9 West Lanox Street, Chevy Chase
(HPC Case No. 35/13-085)
Chevy Chase Village Historic District

SUBJECT: Revision to approved HAWP (Case 35/13-08S), for rear terrace installation at 9 West Lenox Street, Chevy Chase, **Chevy Chase Village Historic District**

SUBJECT: Revision to approved HAWP (35/13-08S), for garage roof replacement and dovecote installation and minor revisions to an approved HAWP at 9 West Lenox Street, Chevy Chase Village Historic District

SUBJECT: Historic Area Work Permit #493647, roof replacement and minor revisions to approved HAWP

DESIGN SKETCH
SK-34A

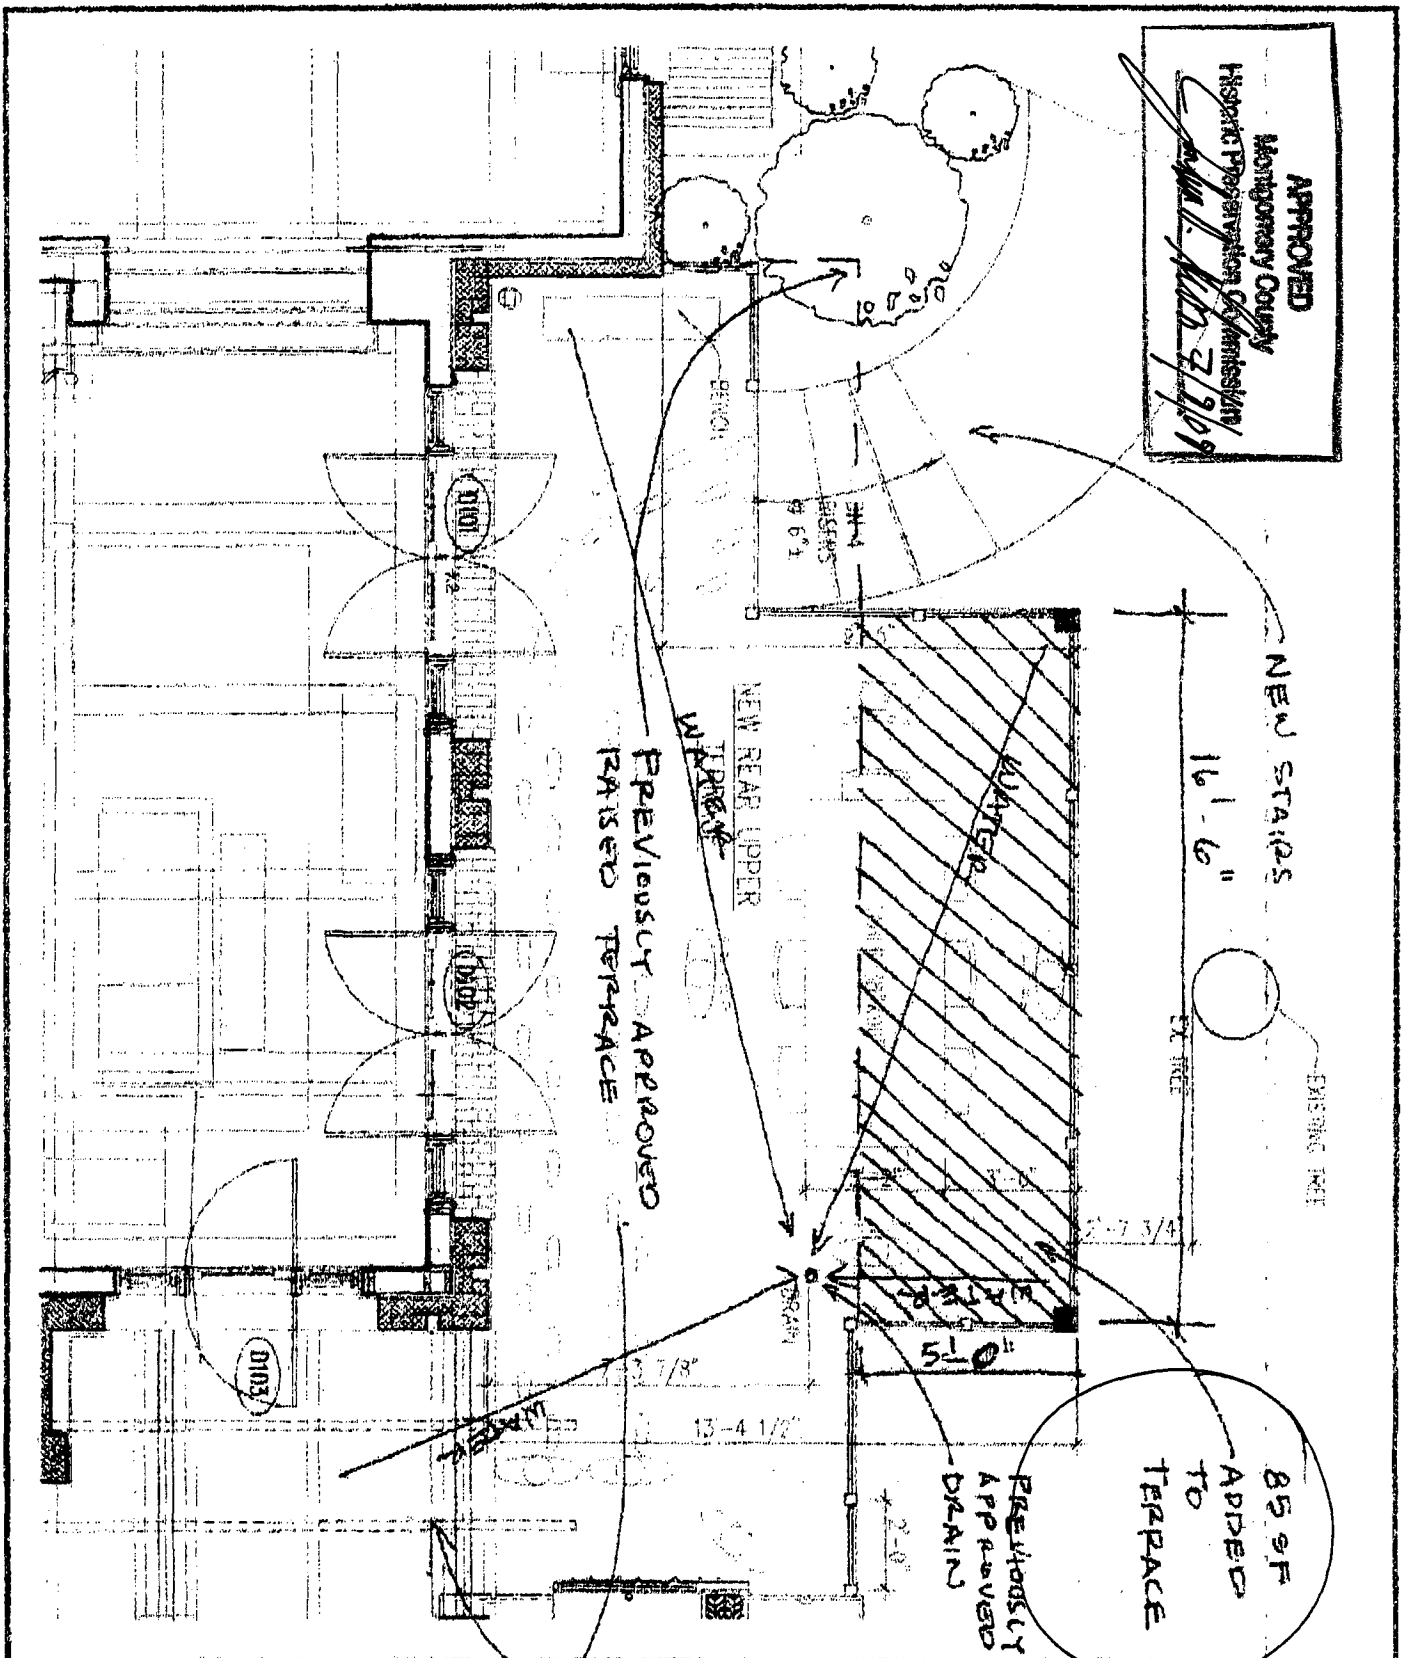
NEW STAIRS
 16'-6"

NEW REAR UPPER
 TERRACE

85 SF
 ADDED
 TO
 TERRACE

STAFF RECOMMENDATION: Staff is recommending that the HPC approve this change.

① LEFT SIDE ELEVATION
SCALE: 1/8" = 1'-0"

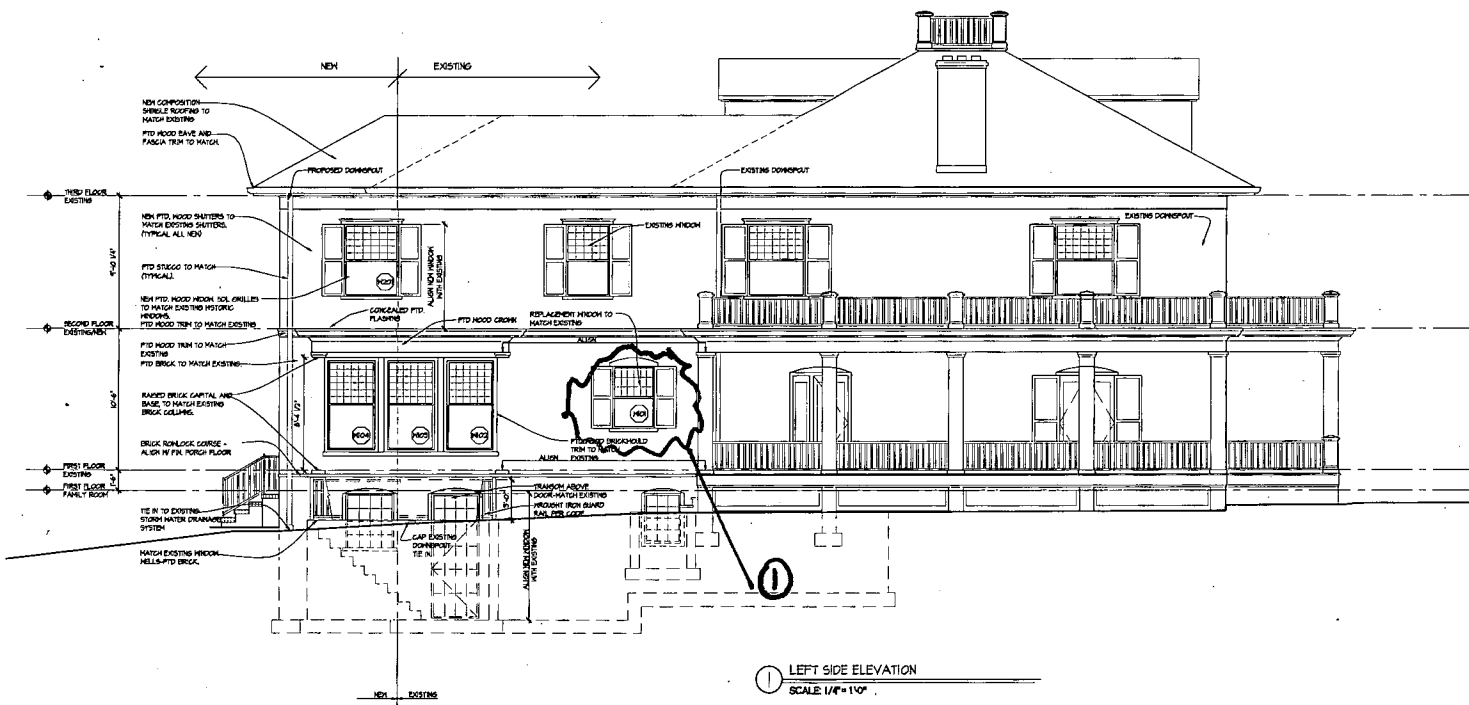
1. Remove two non-historic, double-hung windows from the c.1990 addition and install a new simulated divided light wooden window on the 1st story.

STAFF RECOMMENDATION: Staff is recommending the HPC allow staff level approval for the proposed changes.

① RIGHT SIDE ELEVATION
SCALE 1/4" = 1'-0"

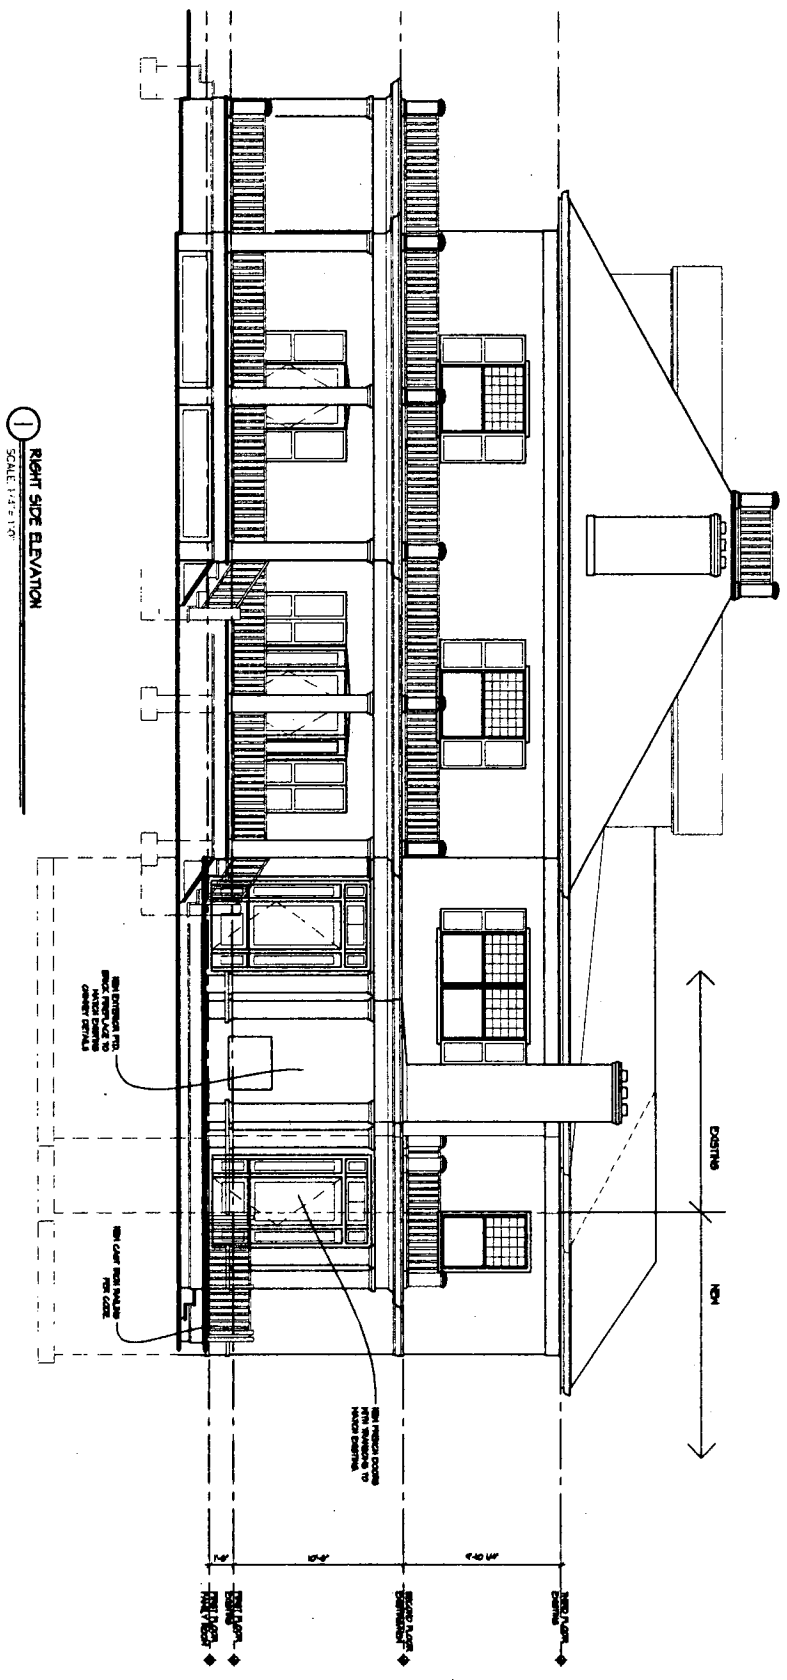
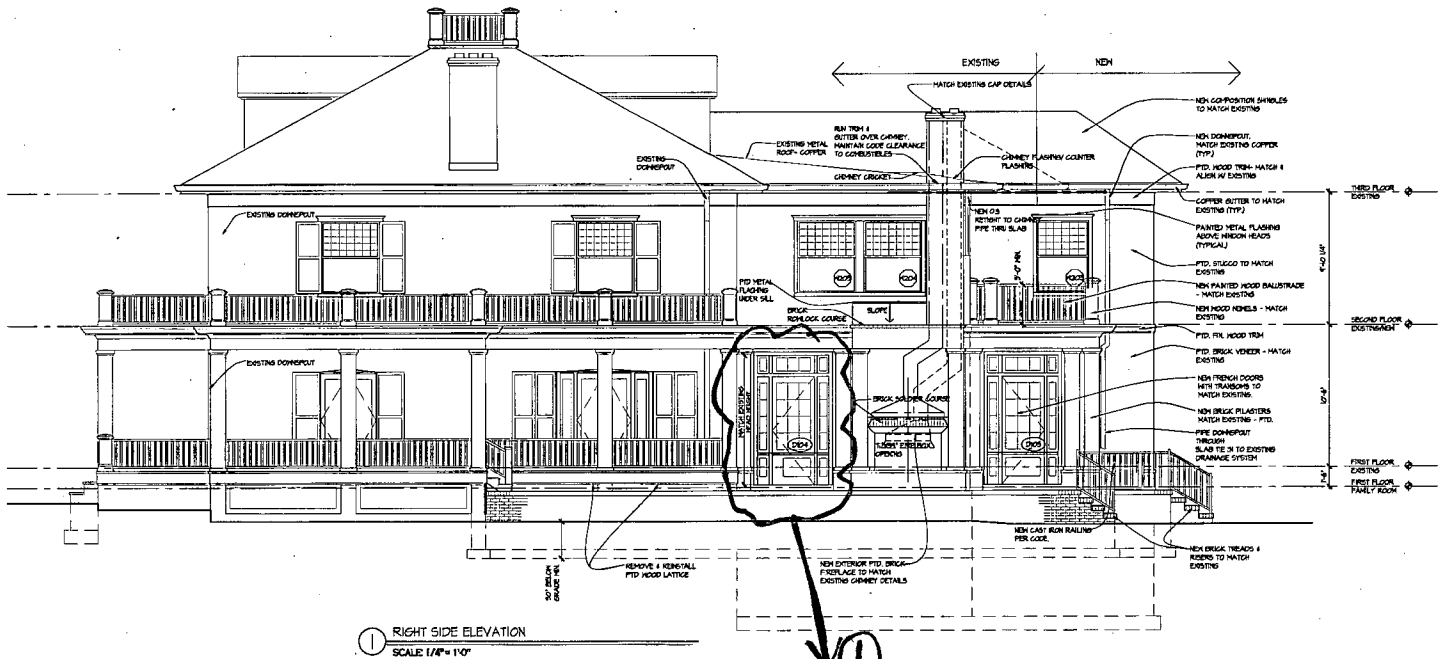
1. Remove one French door from the c.1990 addition and install a new simulated divided light wooden French door in the same location.

1 REAR ELEVATION
SCALE 1/4" = 1'-0"

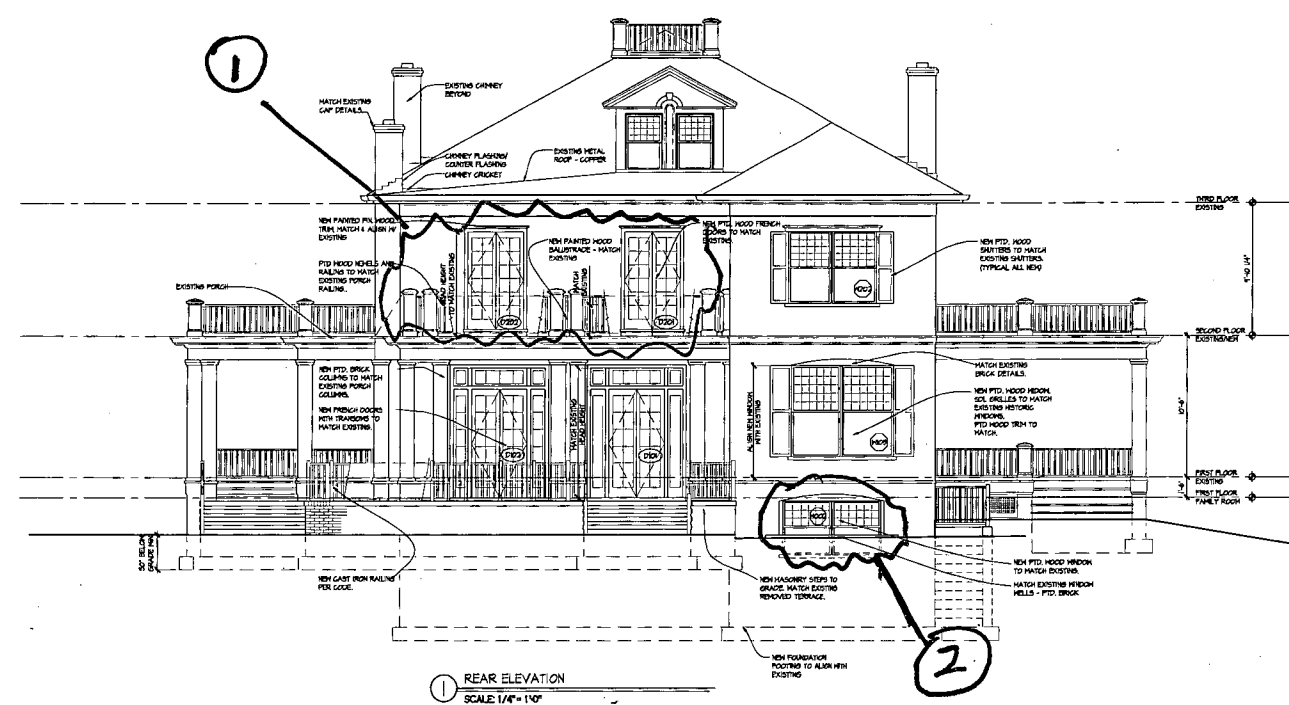
1. Install two simulated divided light wooden French doors on the 2nd story. The proposed doors will serve as access to the proposed balcony on the new addition.
2. Install two double-hung simulated divided light wooden basement level windows.

③ GARAGE - FRONT ELEVATION
 SCALE: 1/4" = 1'-0"

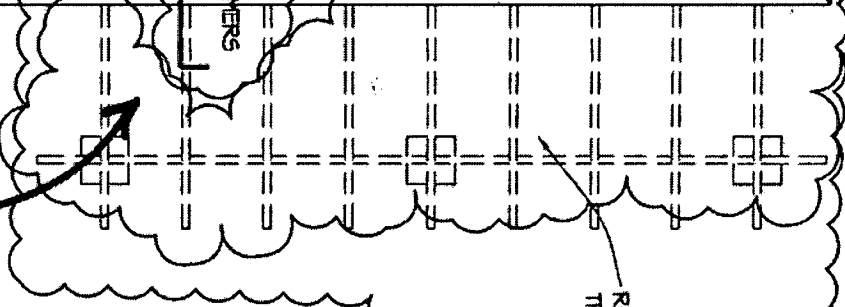
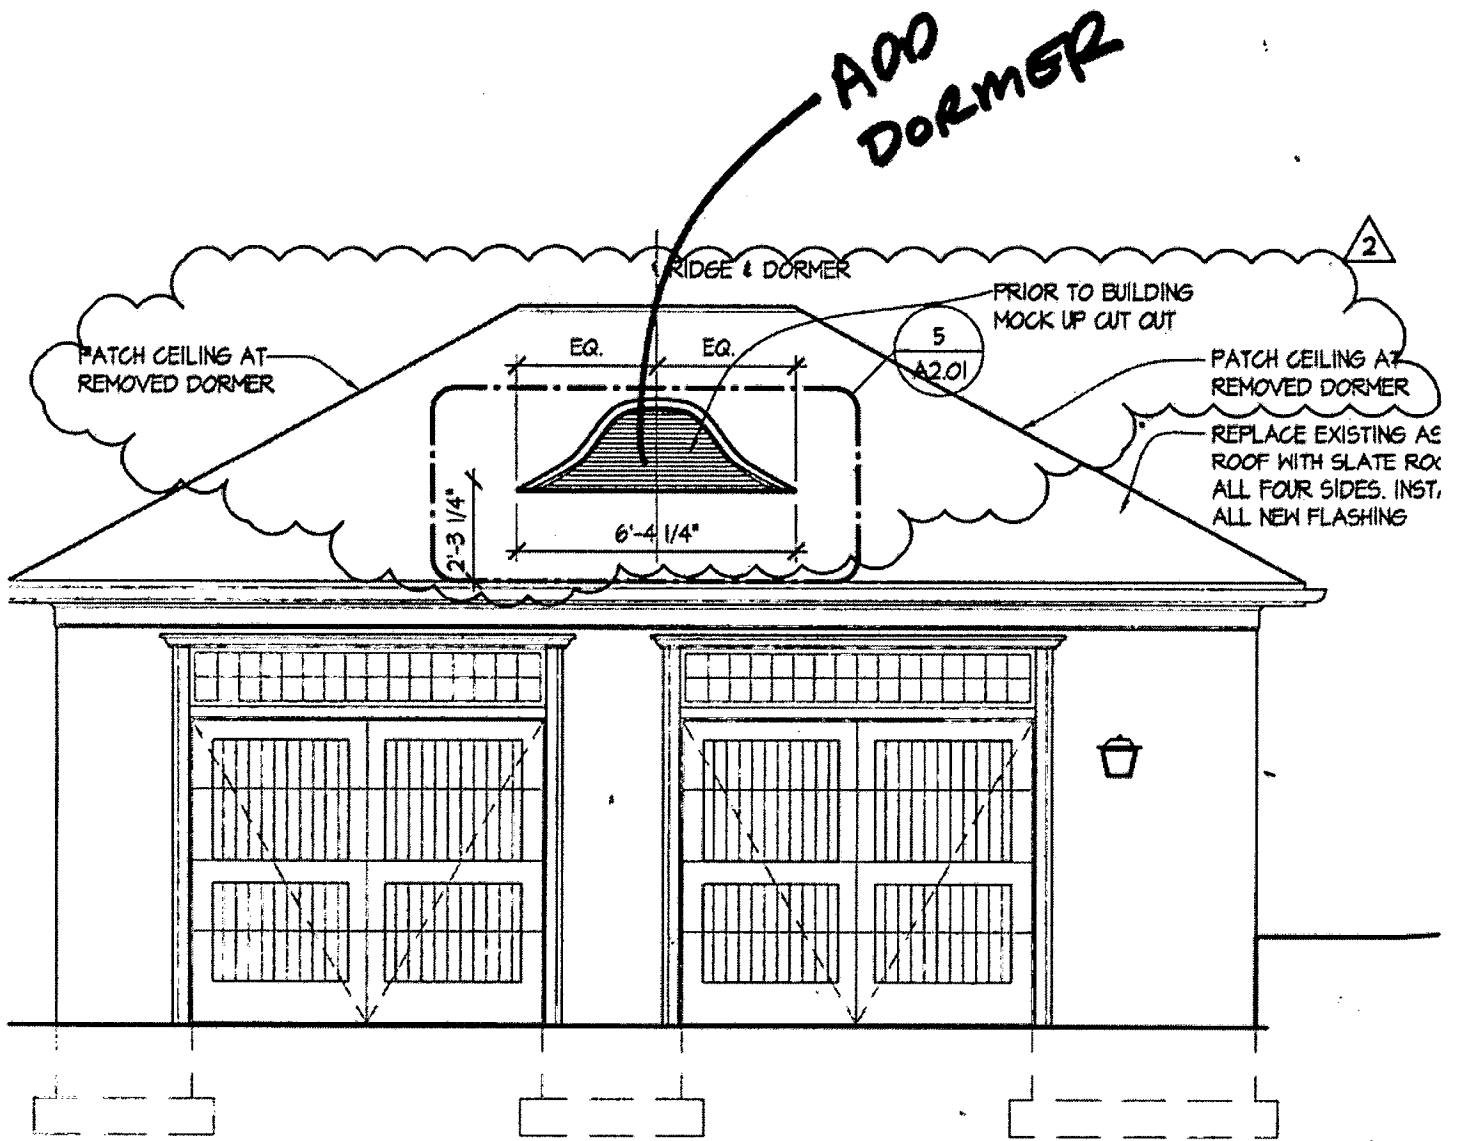
ADD
EYEBROWS

REMOVE EXISTING
ROOF VENTS BOTH
SIDES, REPAIR
SHEATHING AND COVER
WITH NEW ROOFING

REMOVE
SIDE
EYEBROWS

NEW EYEBROW DORMERS
EA SIDE

REMOVE
TRELLIS.

REMOVE EXISTING
TRELLIS AND COLUMNS

STAFF RECOMMENDATION: The revised proposal is consistent with the Chevy Chase Village Historic District Guidelines for alterations to a detached garage; which recommend lenient scrutiny and compatibility with the main building. Staff is recommending that the HPC allow this change to be approved at the staff level.

HPC DECISION: APPROVED 02/25/09

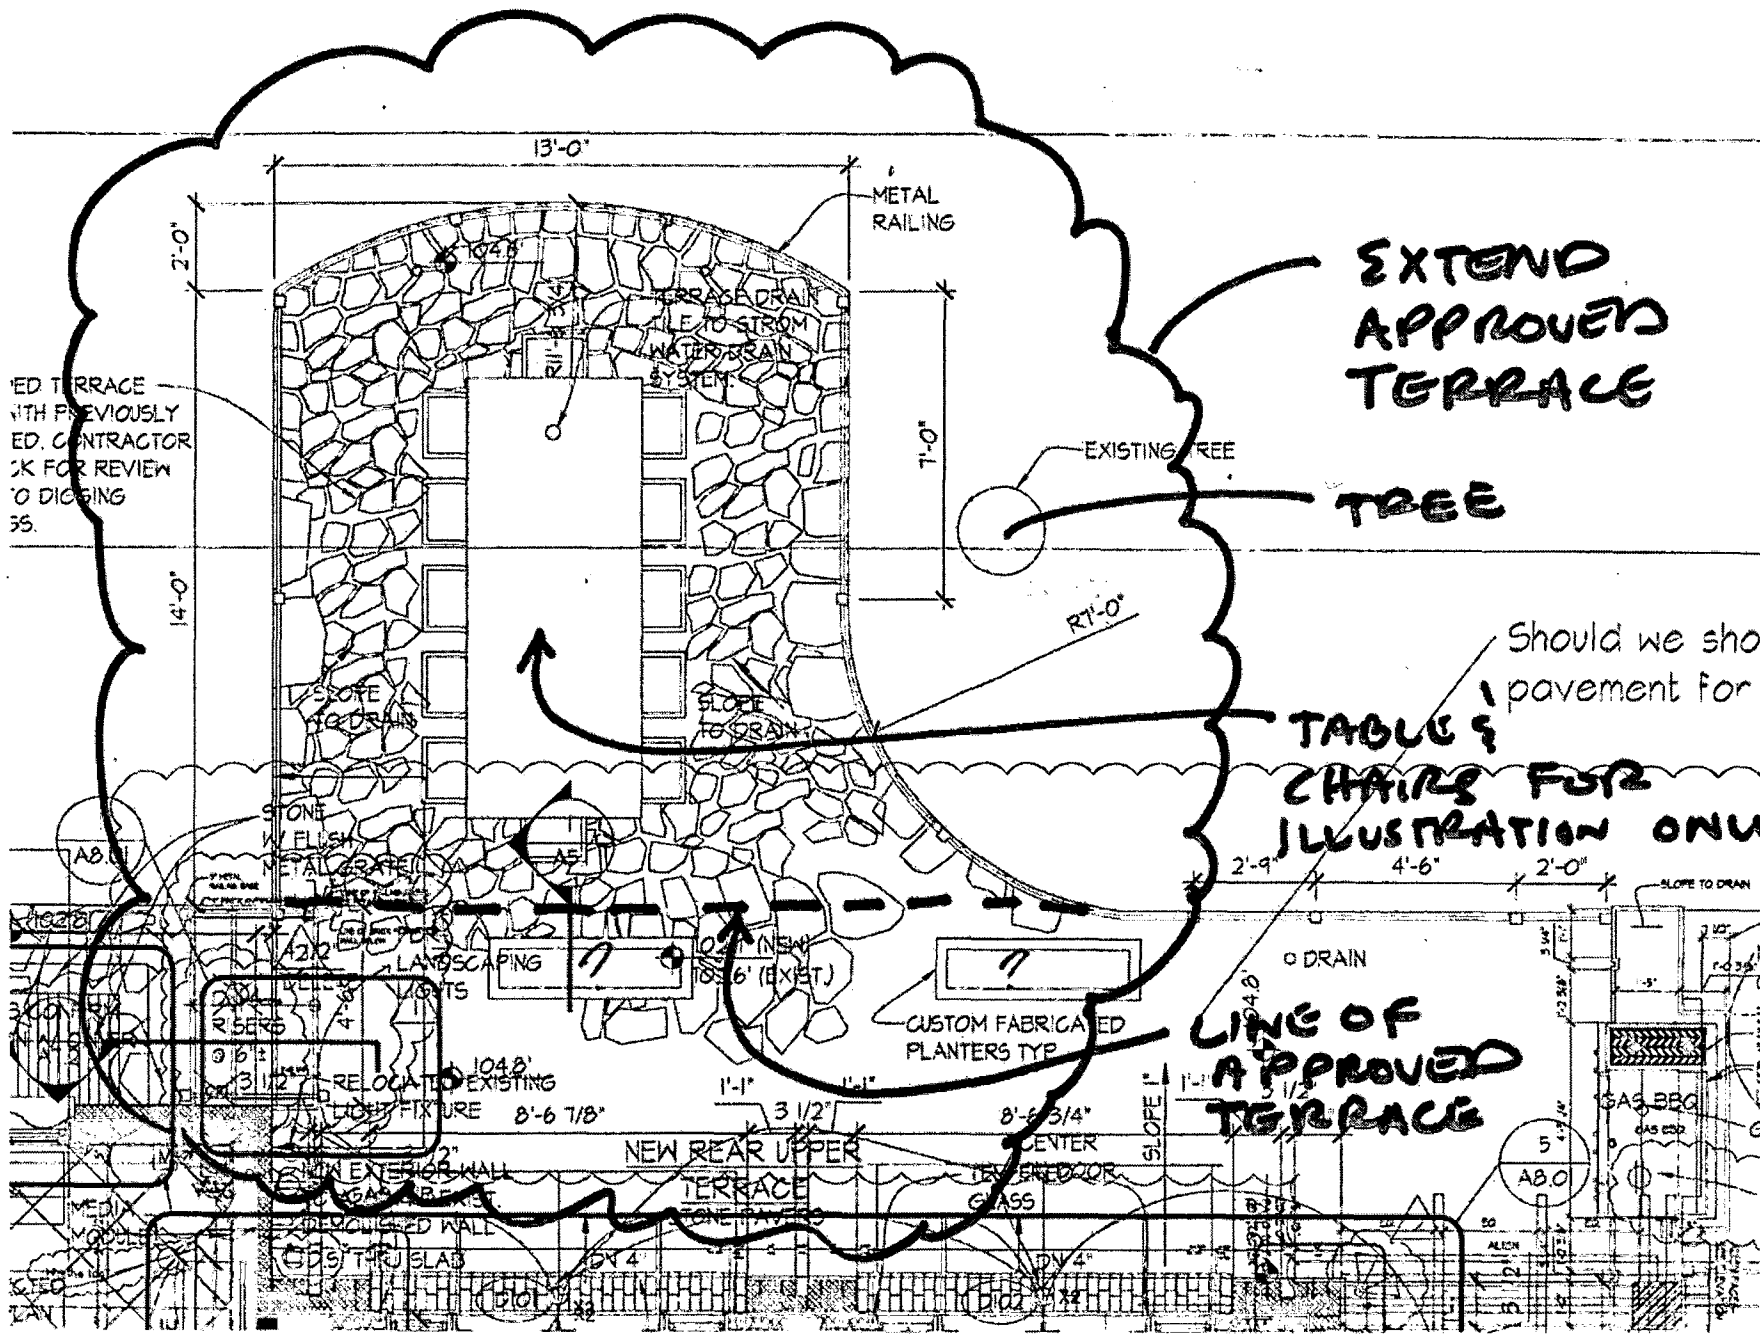
EXTEND APPROVED TERRACE

Should we show pavement for

LINE OF APPROVED TERRACE
